CERTIFICATE OF APPROPRIATENESS

Property: 1235 Columbia Street, Lot 3, Block 190, Houston Heights Subdivision. The property includes a historic 1,706 square foot, one and half story wood frame single-family residence and erar detached storage shed situated on a 6,600 square foot (50' x 132') interior lot.

Proposal: New Construction – The applicant was denied a Certificate at the September 2014 HAHC meeting for a front detached carport. The carport was setback 30' from the front property line. The applicant has revised the proposal and is now requesting approval for a detached carport that will be setback 66' from the front property line. The carport will measure 10' wide, 23'-6" deep and 12'-2" to the ridge.

EAST ELEVATION – FRONT FACING COLUMBIA STREET

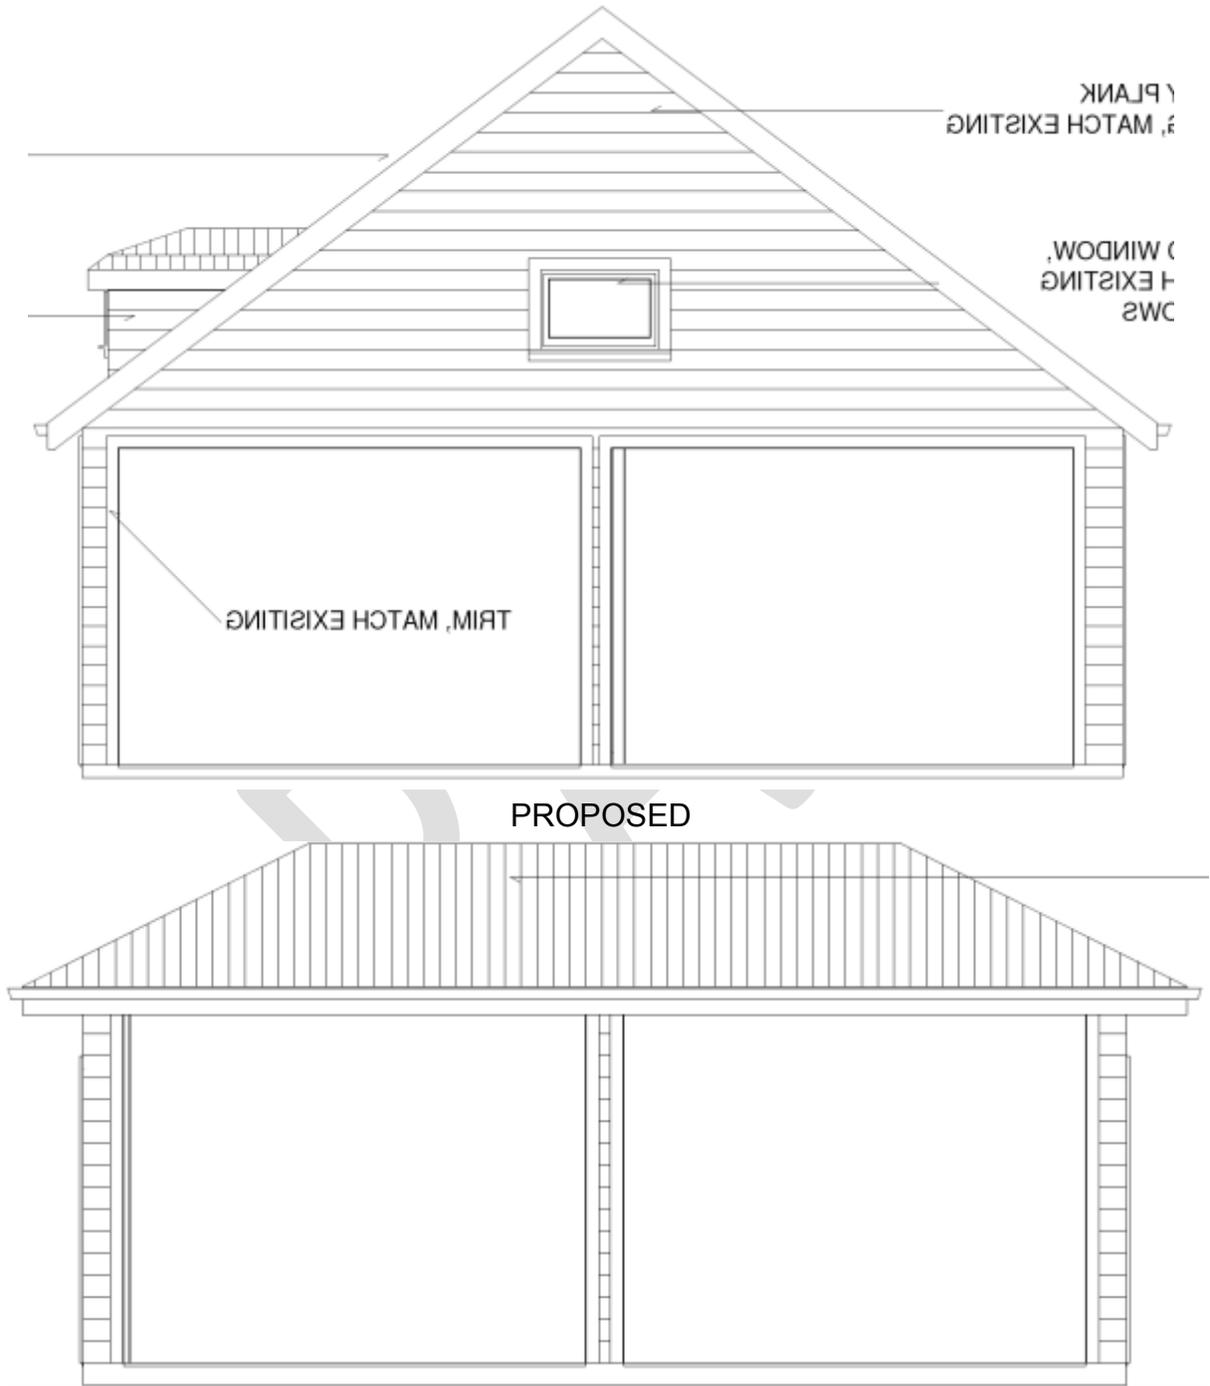
DENIED – 9/25/14

NORTH SIDE ELEVATION

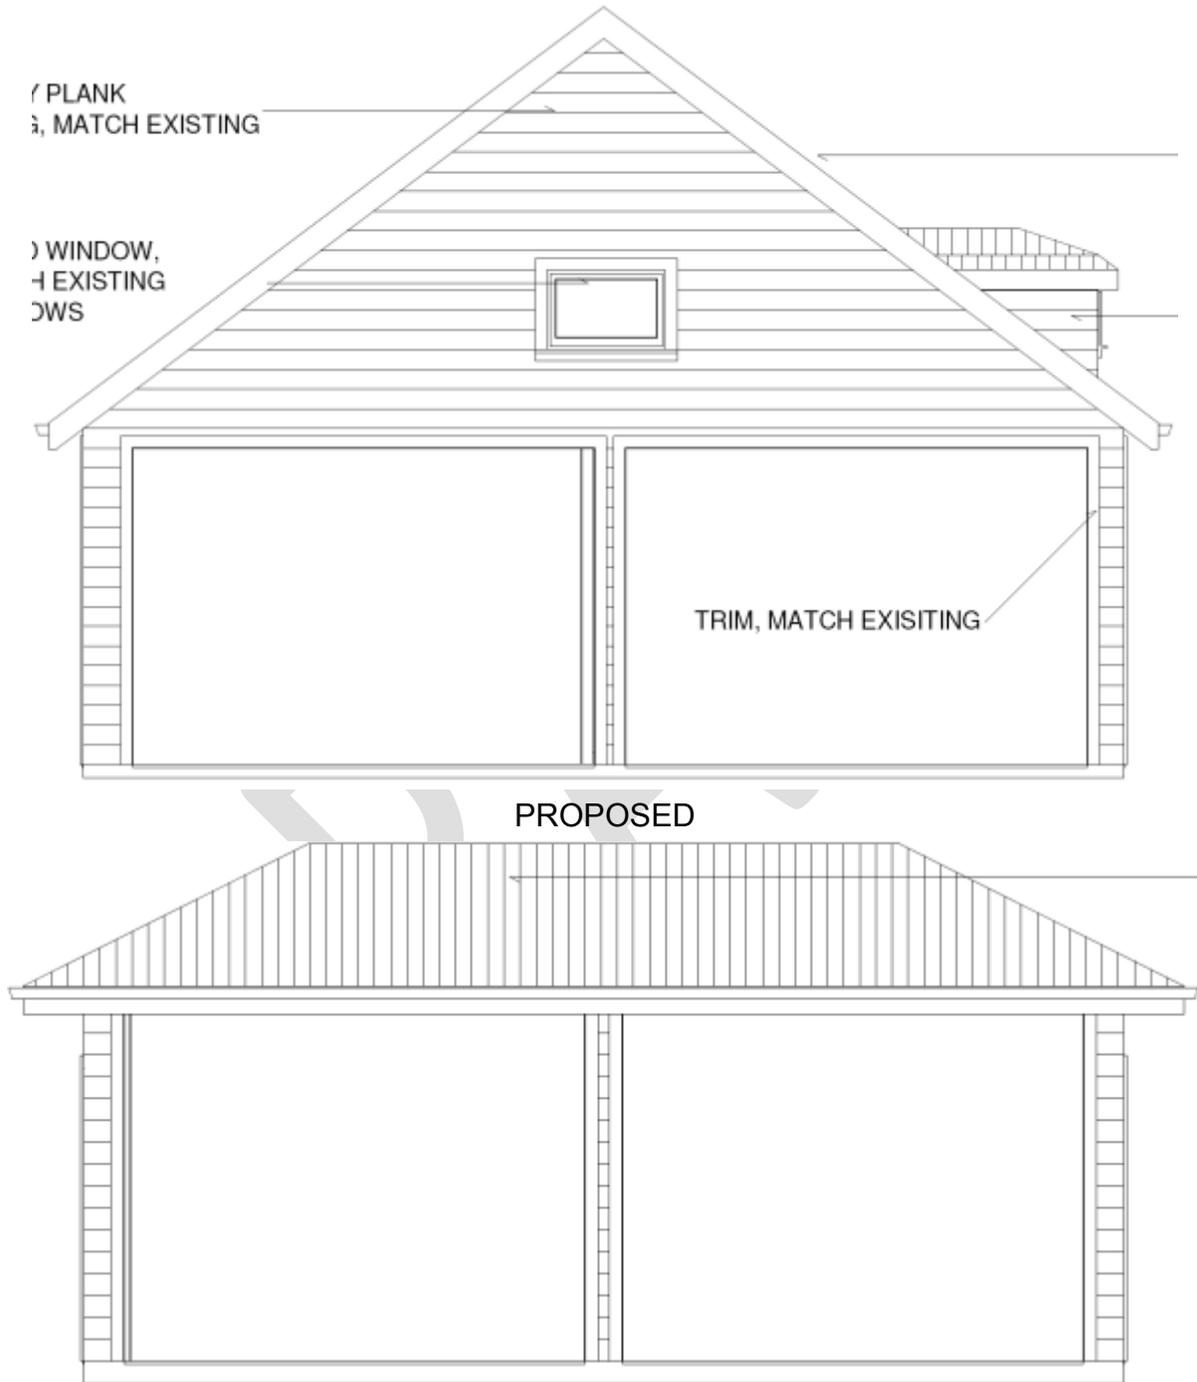
DENIED – 9/25/14

SOUTH SIDE ELEVATION

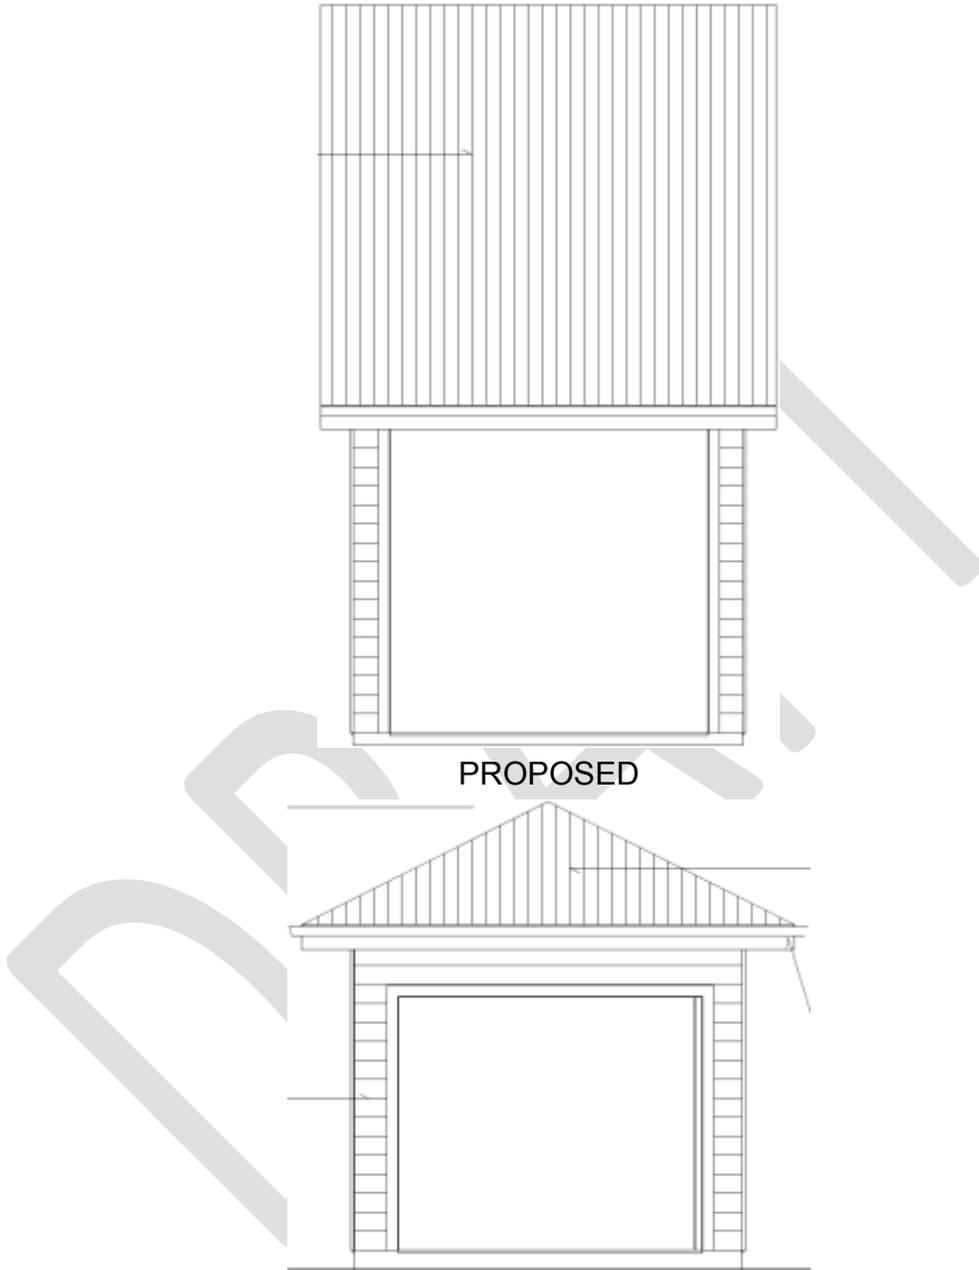
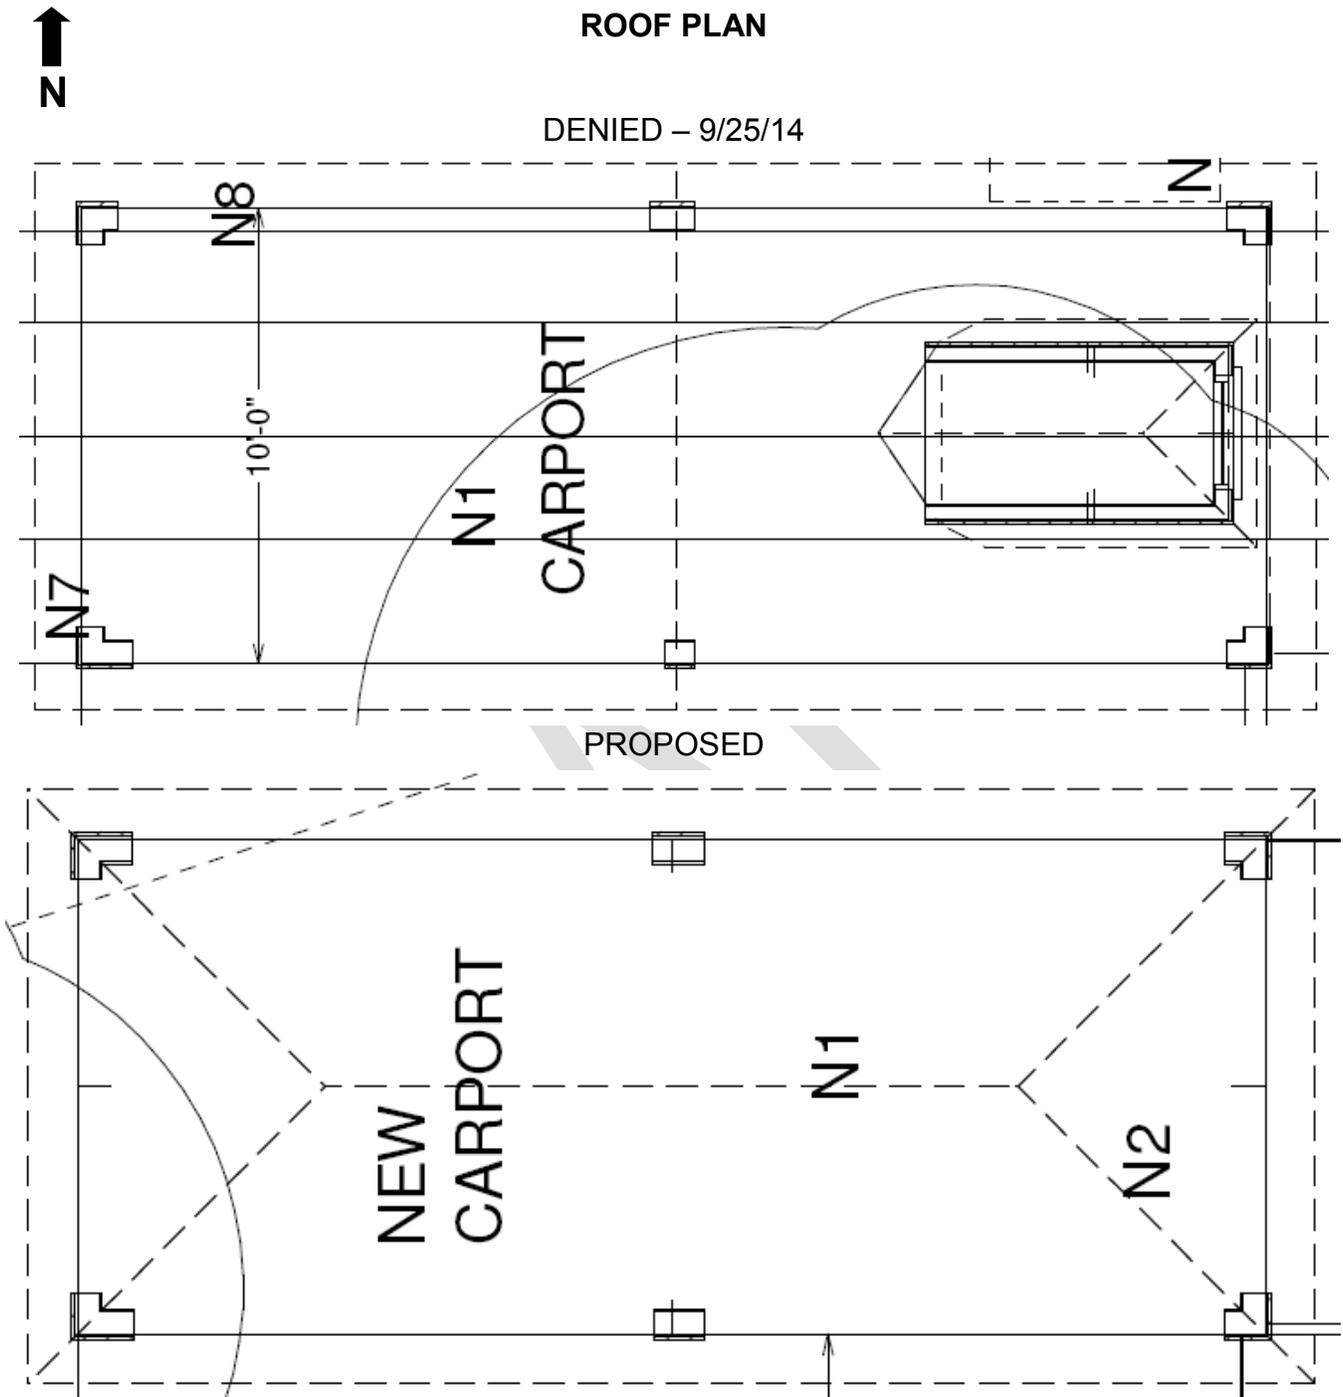
DENIED – 9/25/14

WEST (REAR) ELEVATION

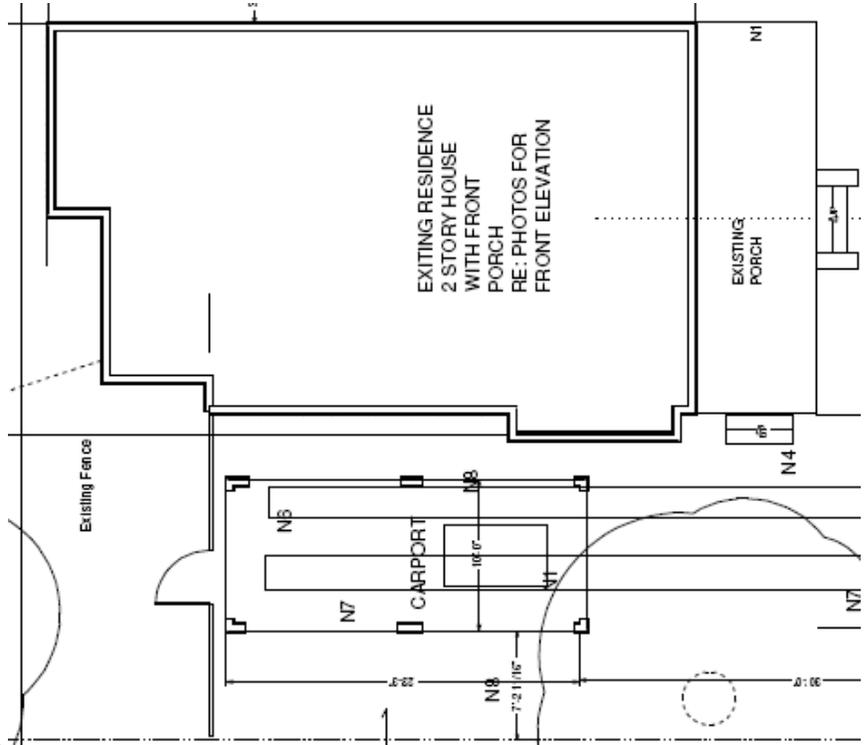
DENIED – 9/25/14

FIRST FLOOR PLAN

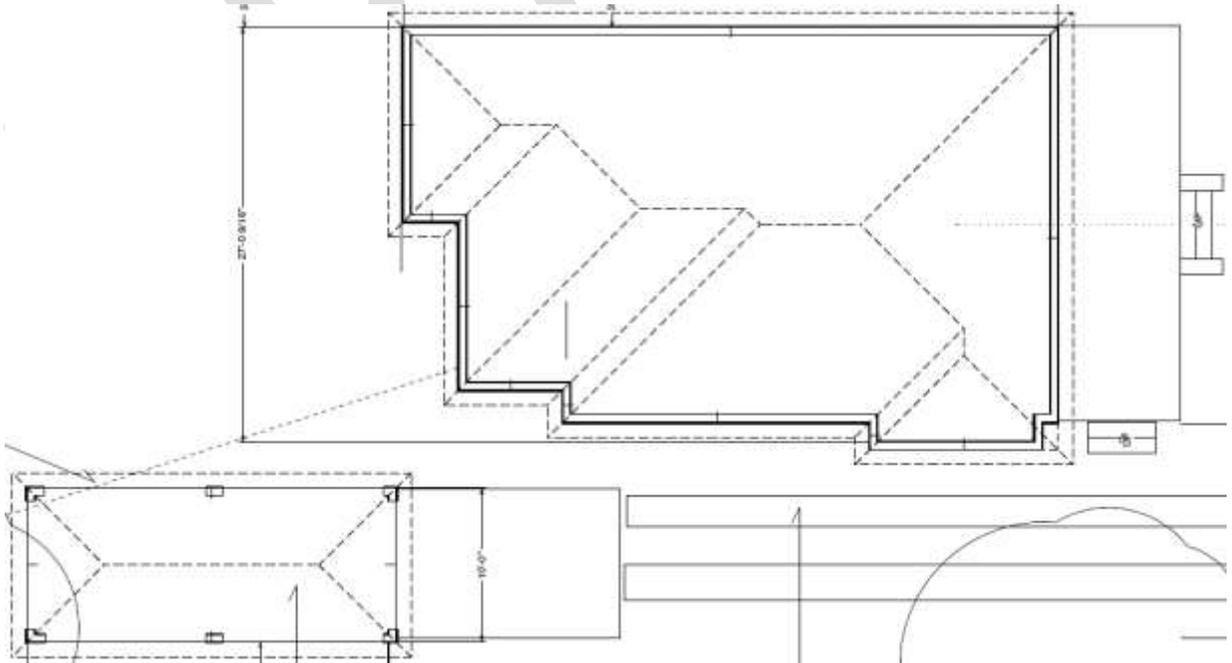
DENIED - 9/25/14

Shape/Mass: The carport will measure 10' wide and 23'-6" deep, (previously proposed 10' wide and 23'-3" deep). The carport will have an eave height of and a ridge height of 12'-2", (previously proposed eave height of 8'-8" and a ridge height of 19'-6").

Setbacks: The carport will be setback 66' from the front property line, (previously proposed 30' from the front property line) , 7'2" from the side, south property line, 32'-10 from the side, north property line, and 42'-6" from the rear property line, (previously proposed 78'-9" from the rear property line).

Roof: The carport will feature a hip roof with a 6/12 pitch and 18" overhang, (previously proposed side gable roof with a 9/12 pitch and a 1' overhang). The roof will be clad with composite shingles.
